Model: AD1-E (Printer Controller)		Date: 30-Jun-97	No: 33
Subject: AD1-E Printer Controller Launching		Prepared by: A.Nakajima	
From: QAC 2nd Field Information Dept.			
Classification:	<input type="checkbox"/> Troubleshooting	<input type="checkbox"/> Part information	<input type="checkbox"/> Action required
	<input type="checkbox"/> Mechanical	<input type="checkbox"/> Electrical	<input type="checkbox"/> Service manual revision
	<input type="checkbox"/> Paper path	<input type="checkbox"/> Transmit/receive	<input type="checkbox"/> Retrofit information
	<input checked="" type="checkbox"/> Other (Launching Information)

Model: AD1-Printer Type 250		Date: 23-Jul-97	No: 35B
Subject: Firmware and Software History		Prepared by: K.Ugaeri	
From: QAC Field Information Dept.			
Classification:	<input type="checkbox"/> Troubleshooting	<input type="checkbox"/> Part information	<input type="checkbox"/> Action required
	<input type="checkbox"/> Mechanical	<input type="checkbox"/> Electrical	<input type="checkbox"/> Service manual revision
	<input type="checkbox"/> Paper path	<input type="checkbox"/> Transmit/receive	<input checked="" type="checkbox"/> Retrofit information
	<input type="checkbox"/>

*Kit number : A6439900 HDD Bracket Kit

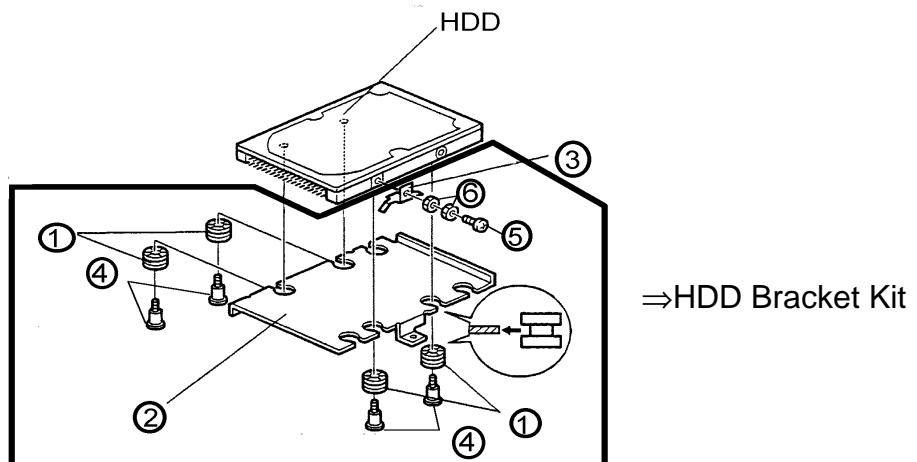
The HDD bracket has been modified for the print-overflow problem caused by vibration from the duplex unit (refer to RTB37). These new brackets have been available from June production in 1997 (the cut-in serial number is A7327060001-)

If you have the print overrun problem on an AD1 with a duplex unit or when you visit a customer whose machine has the old HDD bracket, please change the bracket to a new type.
